**Poor Idle/Check Engine MIL – V6 Engines –
Improved Breather Elbow –
Service Action S158**

MODEL 2000-01 MY
S-TYPE 3.0L
VIN L00001-L86901

ILLUSTRATION 1

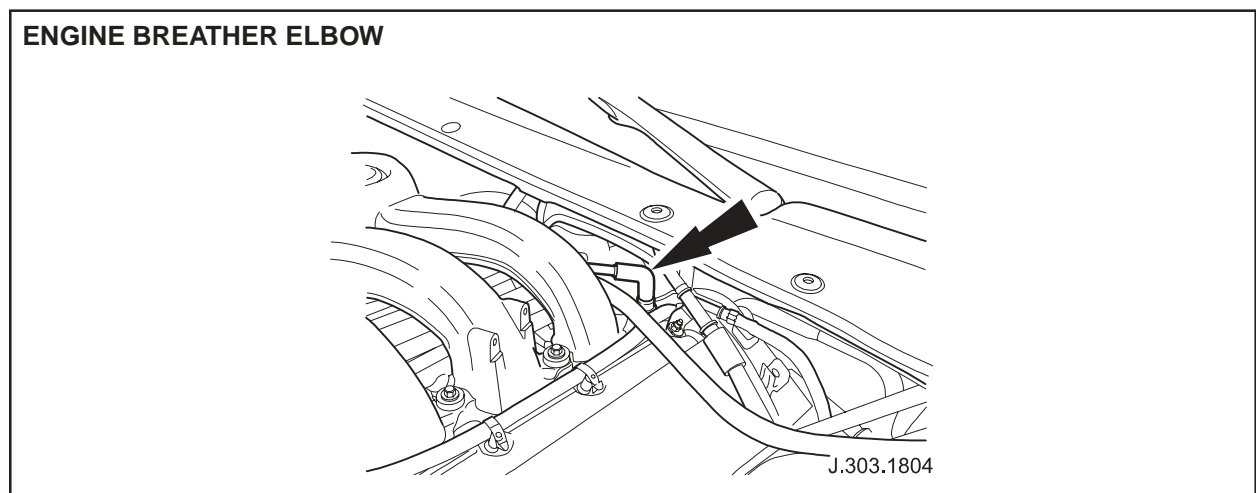
S-TYPE 3.0 liter V6 vehicles, within the above VIN range, are equipped with a 3/8-inch bore 90° rubber elbow as part of the engine breather system. This elbow is manufactured from a type of rubber that is subject to degradation from the gas and vapor that pass through it, resulting, after a period of time, in air being allowed to enter the intake system of the engine.

1. Open hood and fit vehicle protection.
2. Working at the rear of the engine:
3. Remove the engine breather pipe elbow. (Illustration 1)

On 2000-01 S-TYPE 3.0L vehicles within the above VIN range, install a revised breather elbow, at the next available opportunity, as described below.

4. Install the replacement elbow.
5. Remove vehicle protection, close hood.
